STATE OF NORTH CAROLINA  
DEPARTMENT OF TRANSPORTATION

November 04, 2020

Subject: **Request for Modification to Individual Section 404 and Section 401 Water Quality Certification** for the Winston-Salem Northern Beltway from US 52 to US 311 (New Walkertown Road), Forsyth County. Federal Aid Project No. NHP-0074(213), TIP Nos. U-2579D, E& F. Division 9.

**UT to Mill Creek and Mill Creek  
On-site Stream Mitigation Feasibility Report for  
Winston-Salem Northern Beltway  
Forsyth County, North Carolina**

PROJECT REFERENCE NO. <b>U-2579D, E &amp; F</b>	SHEET NO. <b>25</b>
ROADWAY DESIGN ENGINEER	HYDRAULICS ENGINEER
<b>DOCUMENT NOT CONSIDERED FINAL UNLESS ALL SIGNATURES COMPLETED</b>

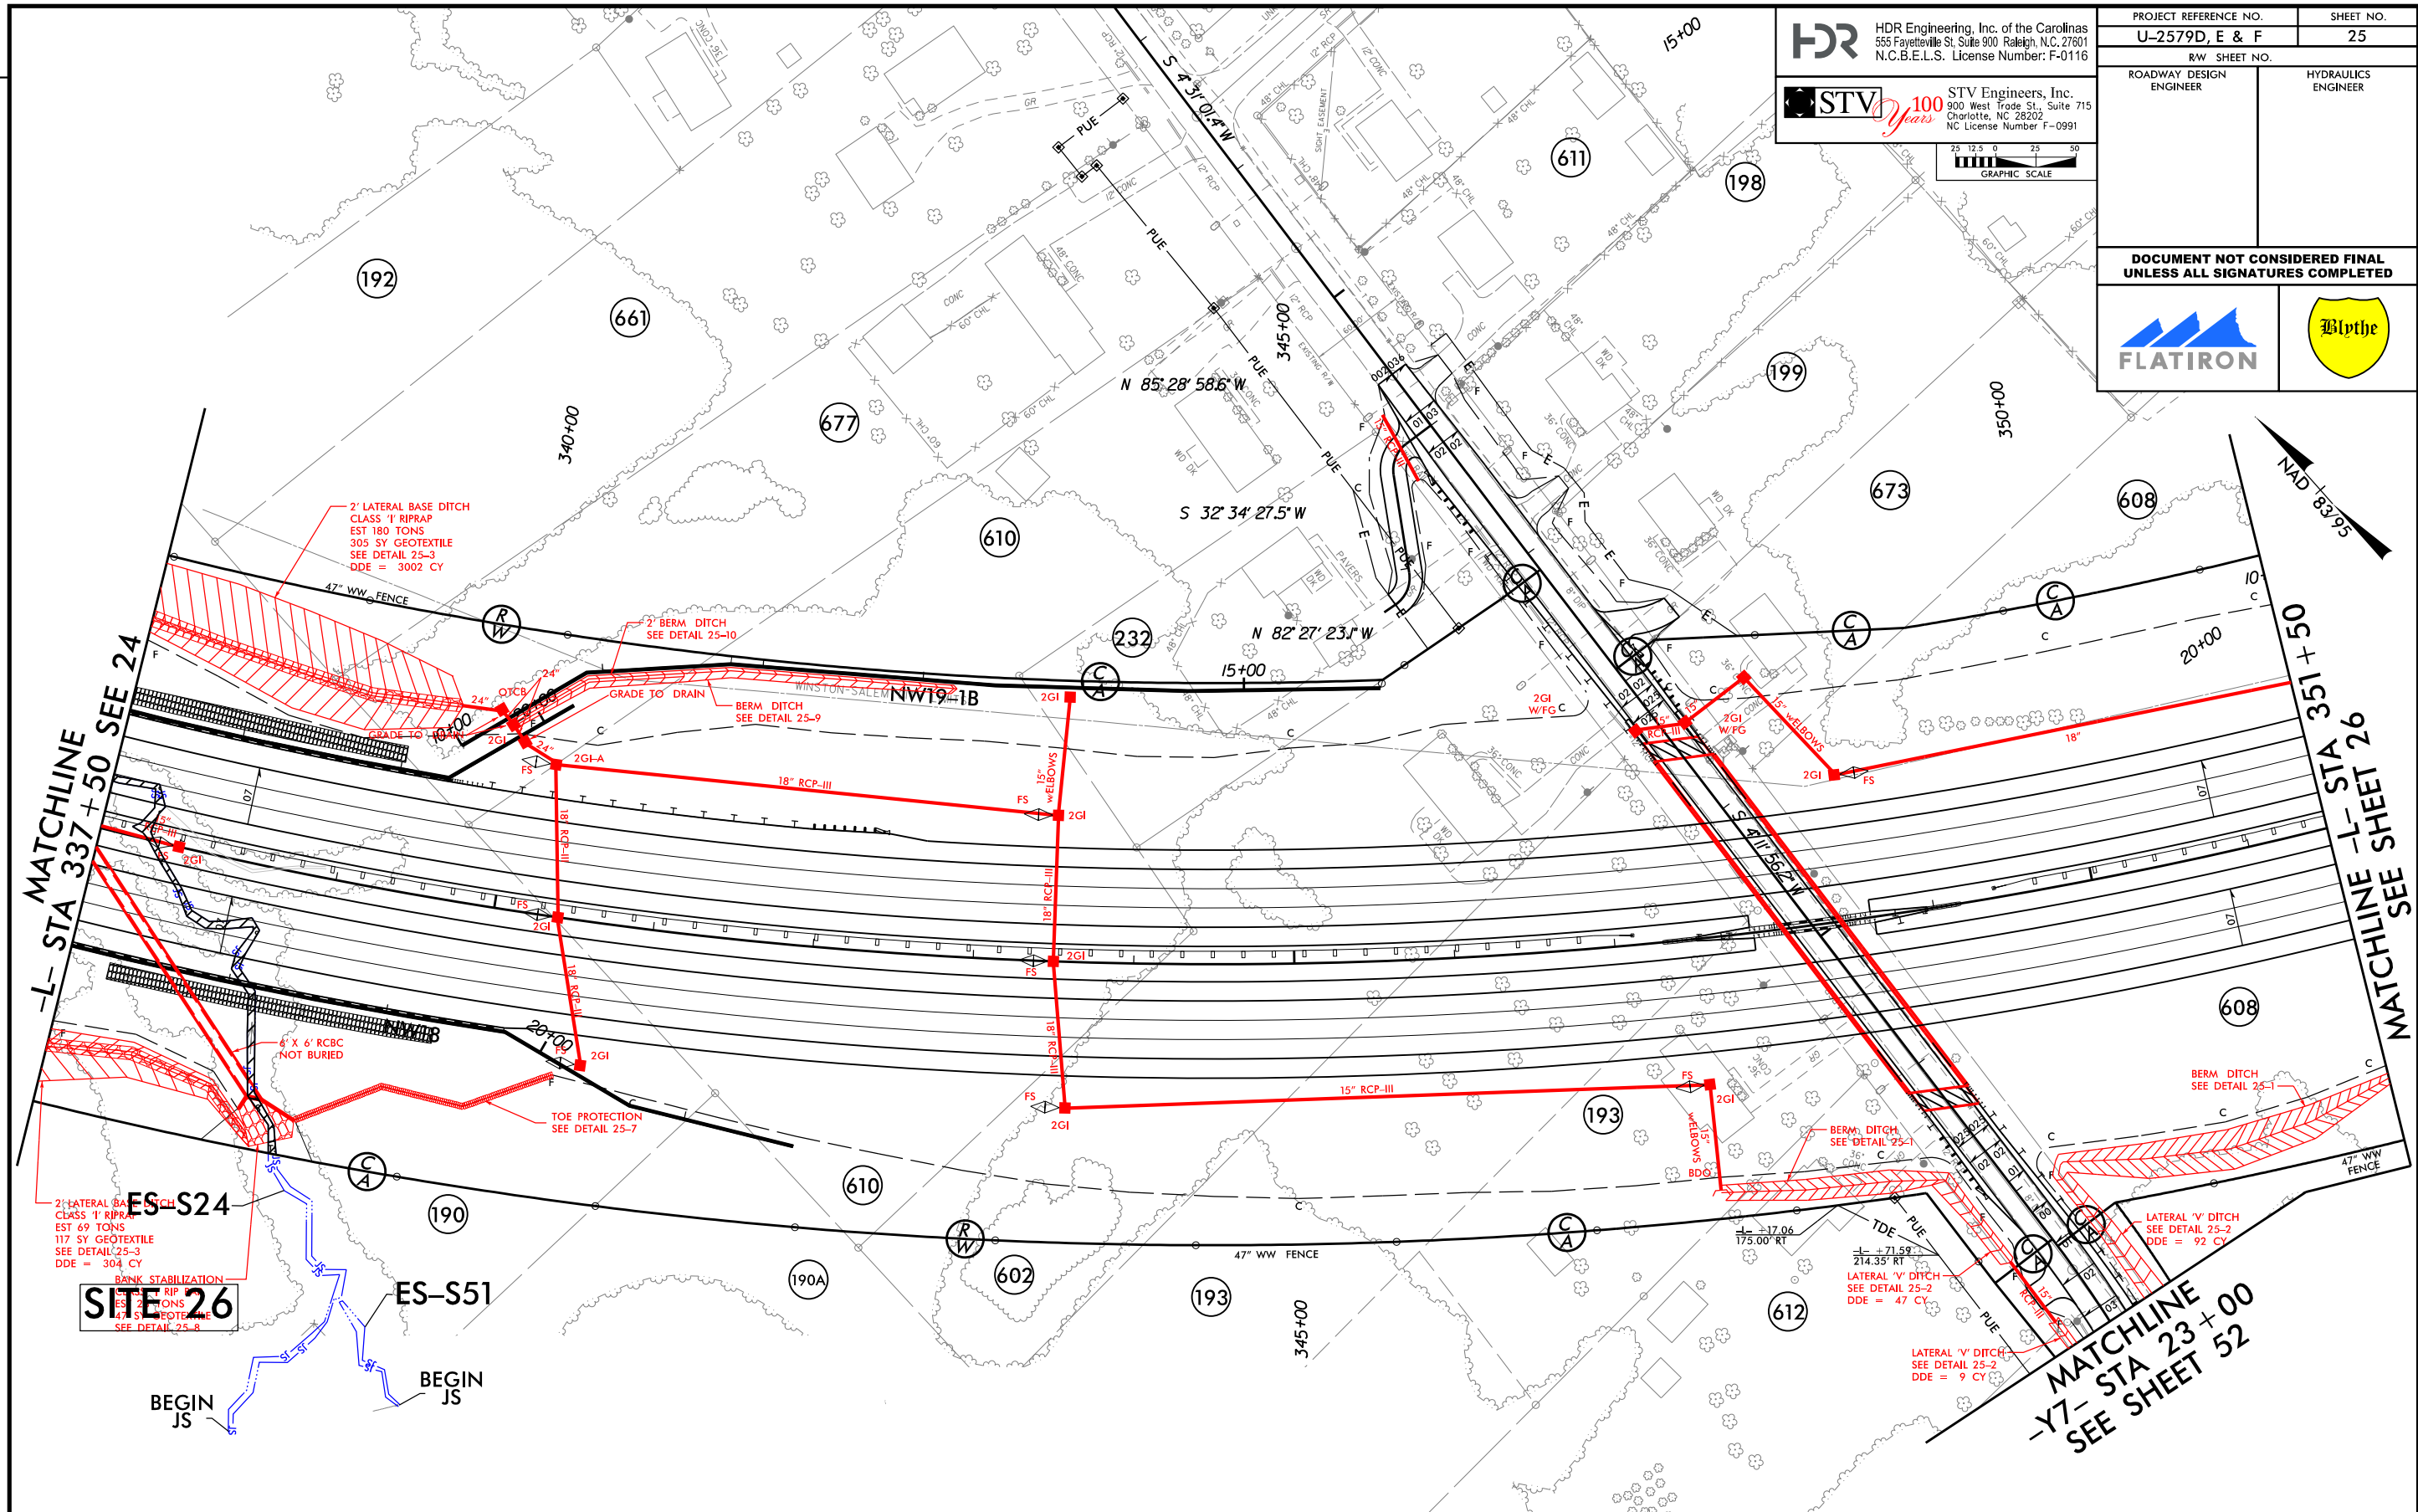
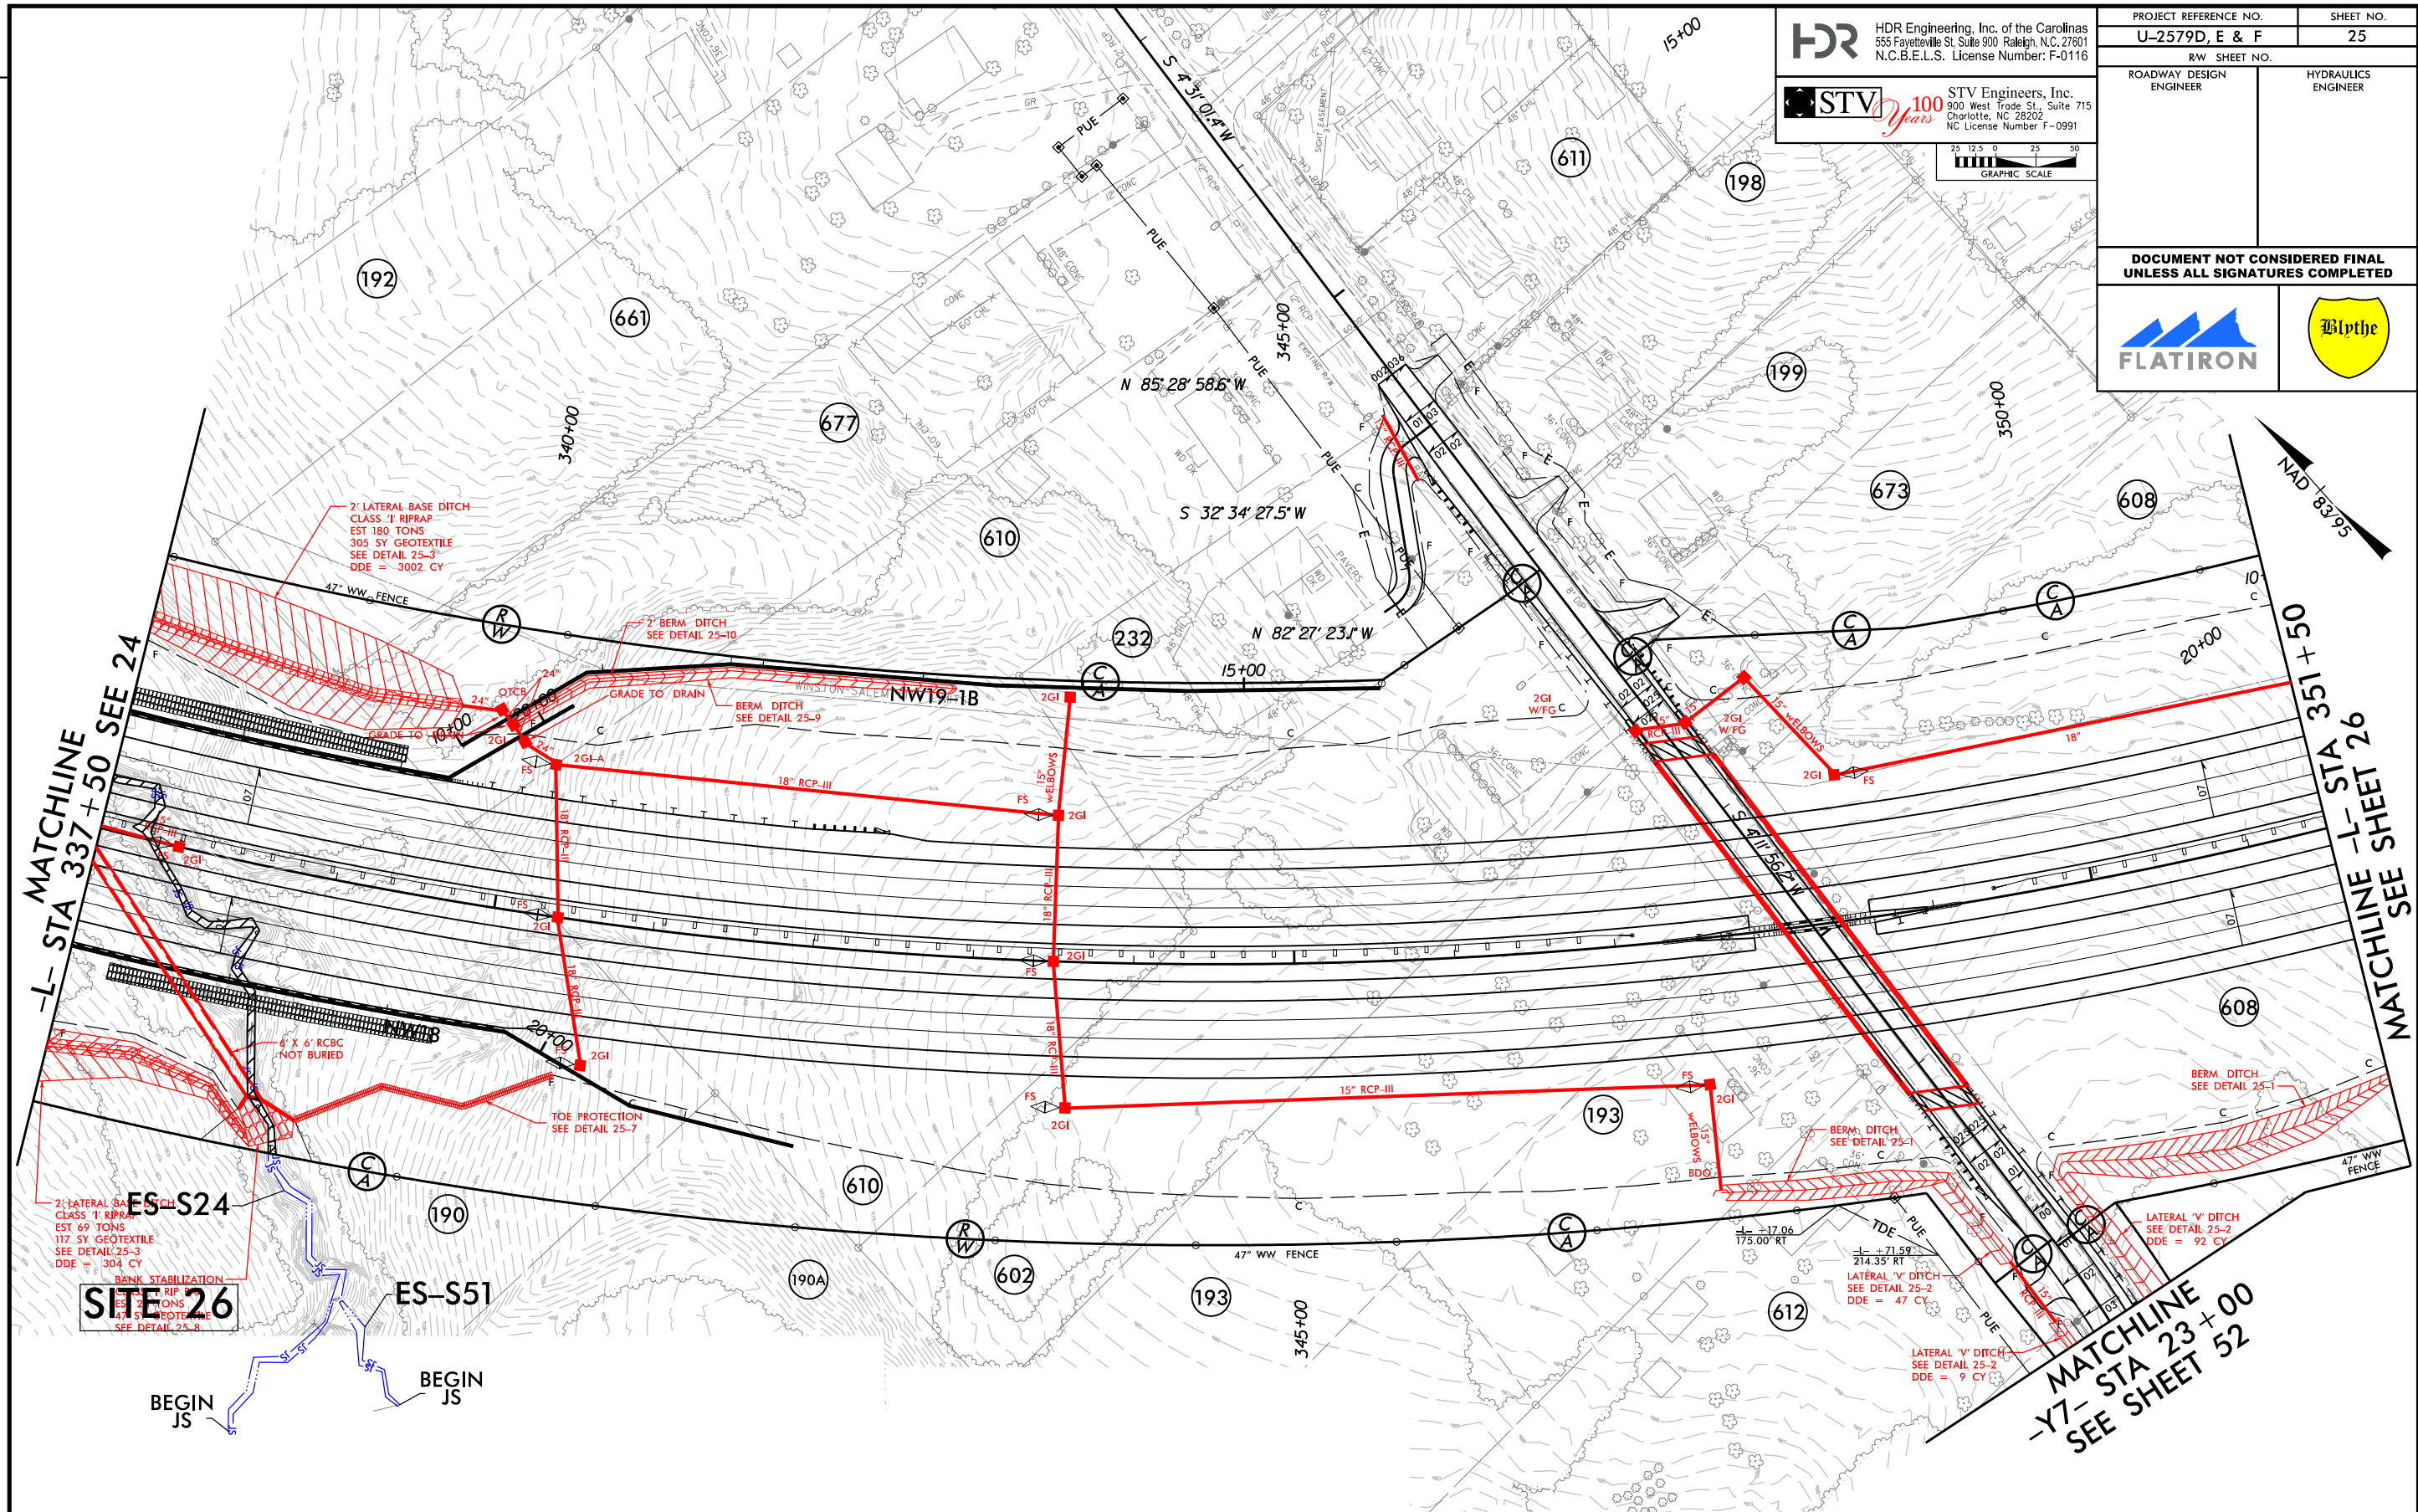
Site 26 (Roadway Plan Sheets 24/25): Site 26 impacts have not changed from the modification dated January 2020; however, the design has changed due to the noise walls. A ditch is required along the toe of fill that will tie to the existing bank stabilization at the inlet of ES-S24. The updated plan sheets are attached.
